April 1, 2025

Re: Variance Application
Applicant: Nastasi
19 Gravelly Point Road
Block 100, Lot 26.19
Borough of Highlands, Monmouth County, New Jersey
Our File No.: HLPB25-03

The Applicant is seeking approval to construct an elevated deck which was not shown on plans recently approved by the Land Use Board.

G102.2

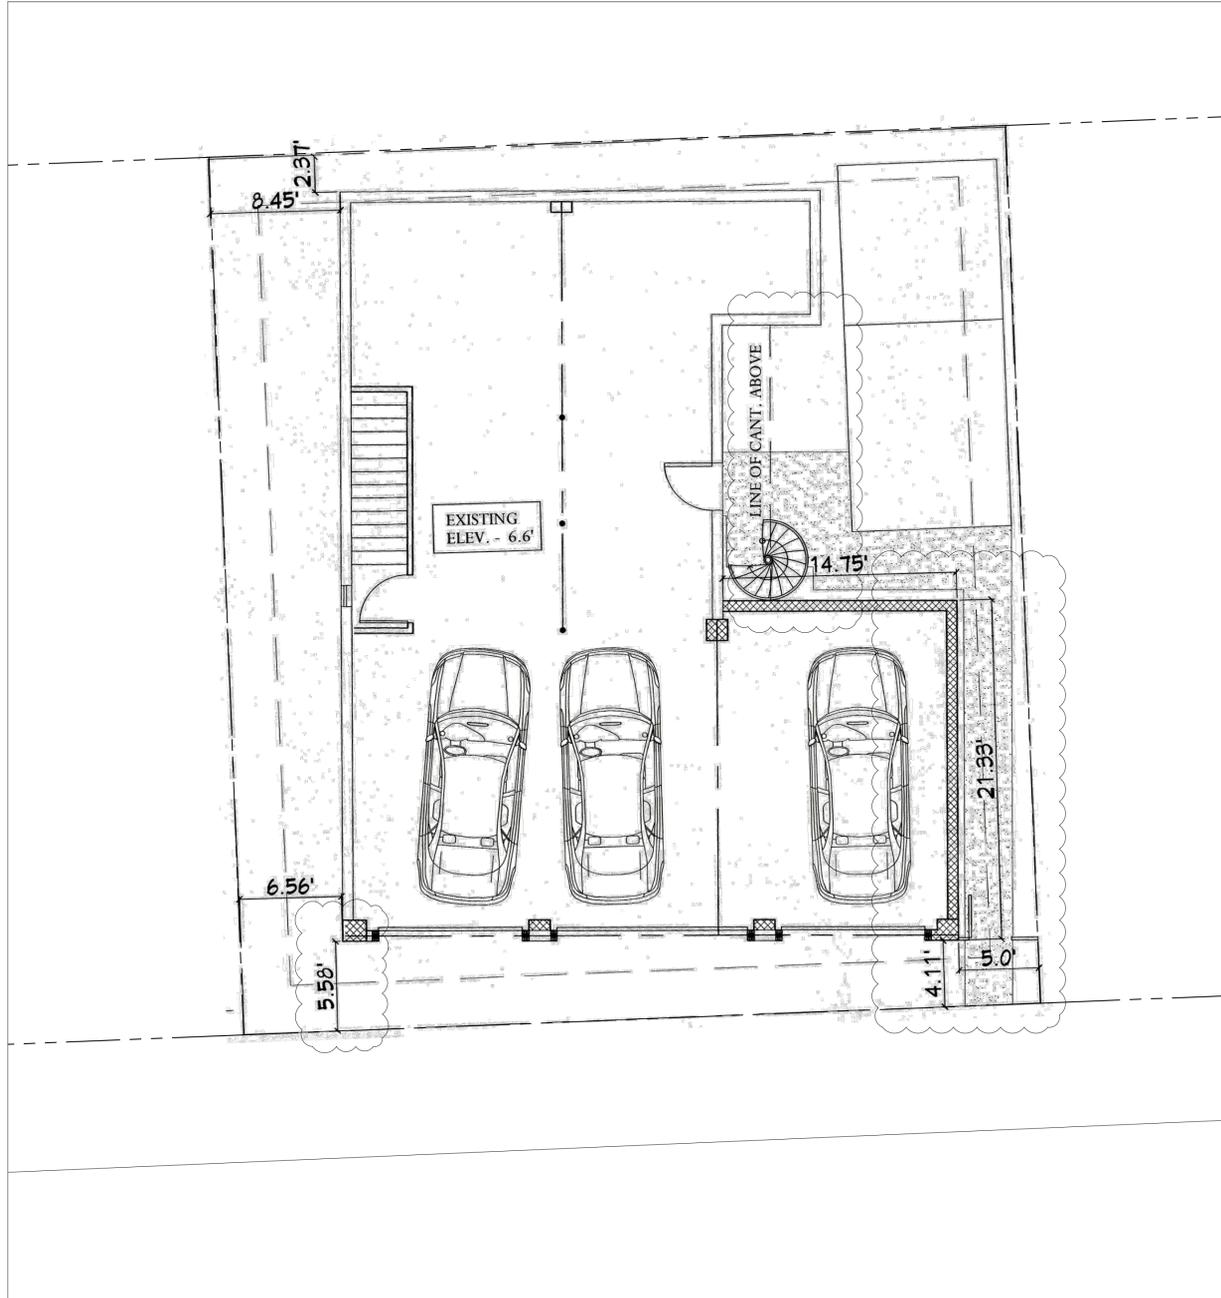
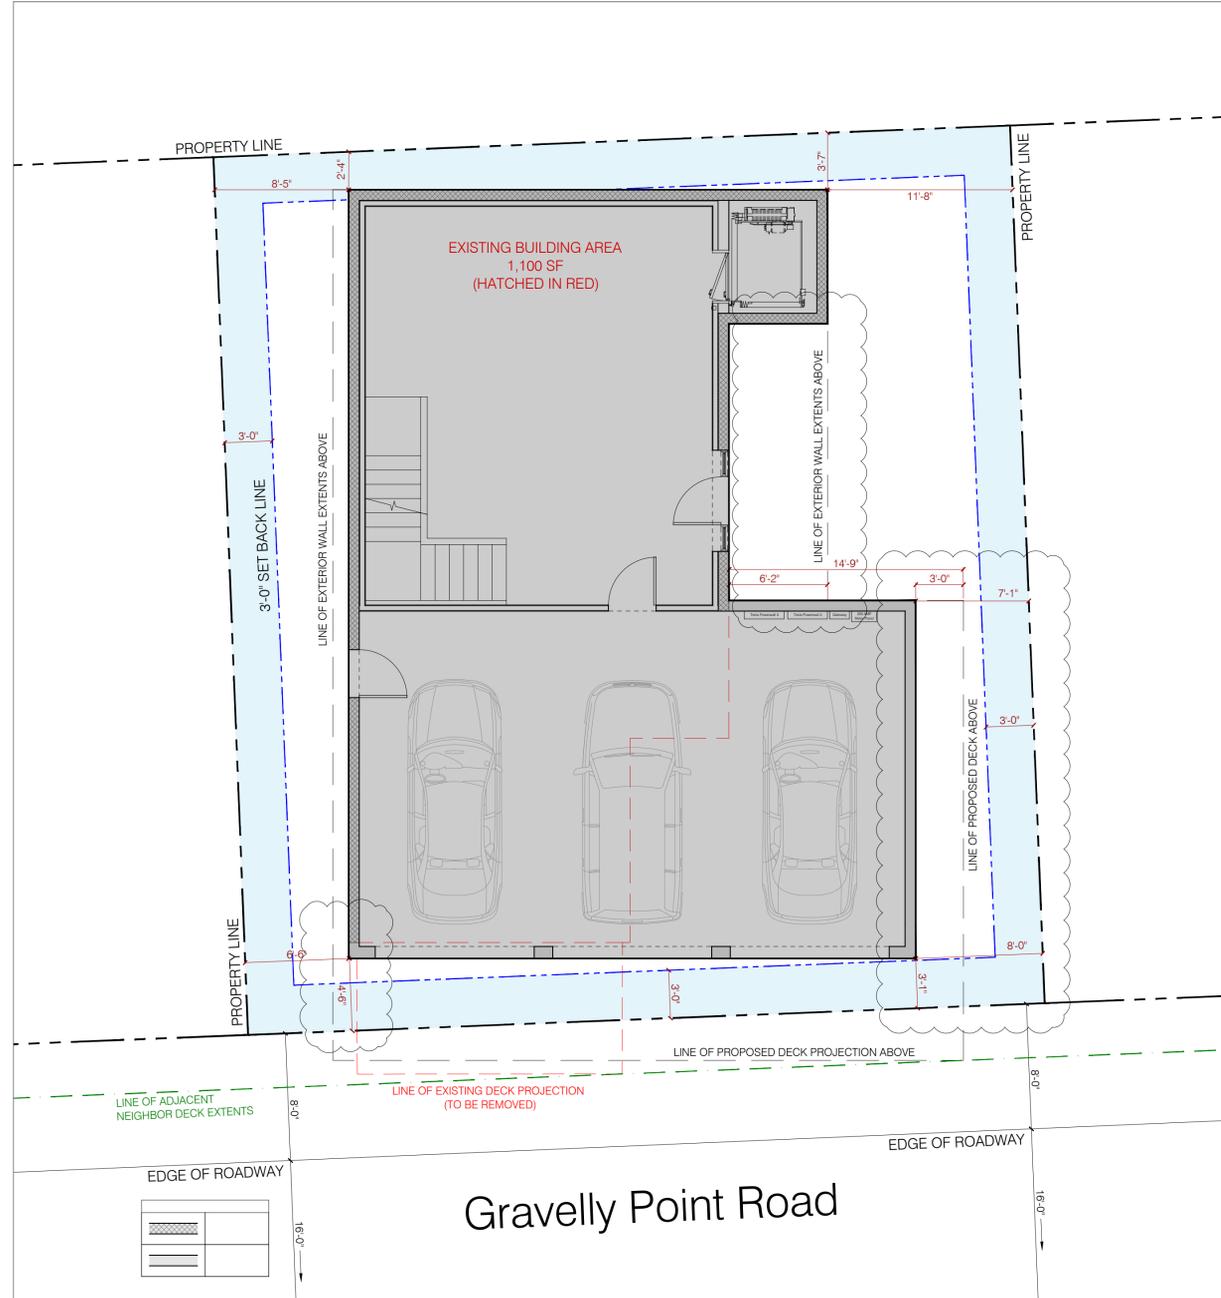
1. A copy of the approved site plan is shown with the proposed site plan with this submission. The maximum building coverage has decreased by 6.1% in comparison to the approved plan
 - a. The proposed addition has been shortened by 3 feet along the front of the dwelling nearest to the right-side yard.
 - b. A foundation wall has been added to the front of the existing dwelling.
 - c. The cantilevered second floor has been extended.

2. The proposed plans indicate a new foundation wall along the front of the existing dwelling which was not delineated on the approved plans. The dwelling is now approximately 1 ft closer to the right-of-way.

The Applicant is placing the proposed elevated deck based upon the second option and has indicated a "line of adjacent neighbor deck extents" and an outline of the existing deck on the plan.

The proposed deck aligns with the neighboring deck according to the plan

The Applicant is required to provide a full view of the neighboring decks. There appears to be no dwelling with decking on the lot to the right.

Please provide internal building and deck dimensions. Please provide deck offsets to the right-of-way.

Please provide the proposed front and side offsets of the proposed deck to the property lines and right-of-way on the plan.
